Re: **3308 4<sup>th</sup> Street Apartment Building**  
**3308 4<sup>th</sup> Street NW**  
**Traffic Circulation Layout**  
Engineer's Stamp 05-02-18 (H14-D109)

Based upon the information provided in your submittal received 05-04-18, the above referenced plan cannot be approved for Building Permit until the following comments are addressed:

3308 4th SREET, NW  
SITE PLAN FOR BUILDING PERMIT

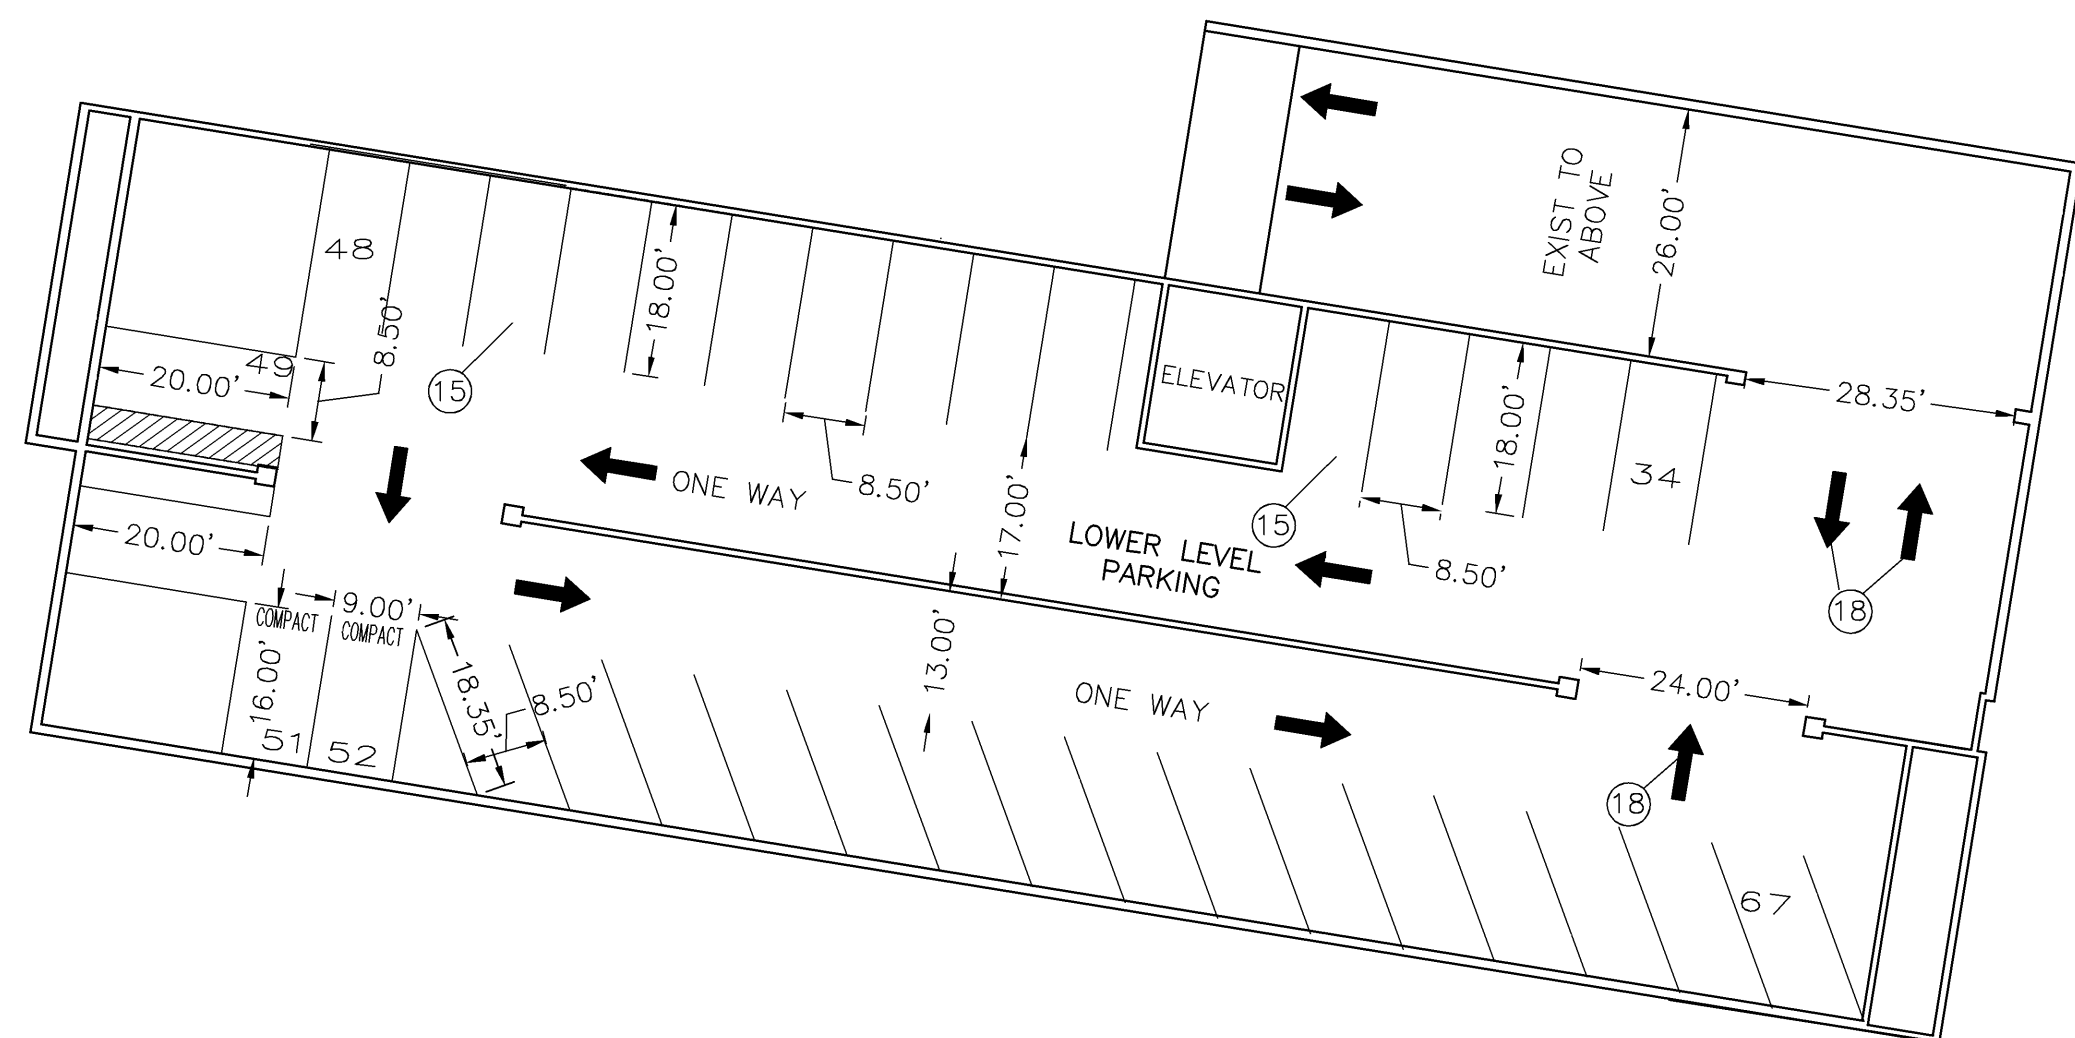
1. Either the two parking space at the front of the site or the pedestrian path may need to be moved. ADA accessible pedestrian pathway should not be placed behind parking space or adjacent to a vehicular way. Vehicle and pedestrian/wheel chair conflicts should be avoided as much as possible.

2. Clarify existing property lines and proposed property lines.
3. Label the compact parking spaces by placing the words "**COMPACT**" on the pavement of each space.

4. The ADA access aisles shall have the words "**NO PARKING**" in capital letters, each of which shall be at least one foot high and at least two inches wide, placed at the rear of the parking space so as to be close to where an adjacent vehicle's rear tire would be placed. (66-1-4.1.B NMSA 1978)

5. Please show turning templates for the design vehicle on the second floor. I am not sure cars will be able to make the turn.
6. The angle parking on the second floor is compact car size, please label the spaces compact. Please provide angles and dimensions.

7. Key Note 15 on the second floor should be 22.

8. Please dimension the openings to the open parking spaces.
9. A 5 ft. keyway is required for dead-end parking aisles. Parking spaces next to the neighbor's property need keyways.

10. Service vehicle and/or refuse vehicle maneuvering must be contained on-site; provide a copy of refuse approval.
11. One-way vehicular paths require pavement directional signage and a posted **"Do Not Enter"** sign at the point of egress. Please show detail and location of posted signs. A sign may be needed on the second level. I also have questions about the parking spaces below the ramp. Will there be an exit onto MRGCD property?

12. Please provide a sight distance exhibit, the exit next to the ramp going up the second level looks like it may have a sight distance issue.
13. Show the clear sight triangle and add the following note to the plan:  
"Landscaping and signage will not interfere with clear sight requirements. Therefore, signs, walls, trees, and shrubbery between 3 and 8 feet tall (as measured from the gutter pan) will not be acceptable in the clear sight triangle."
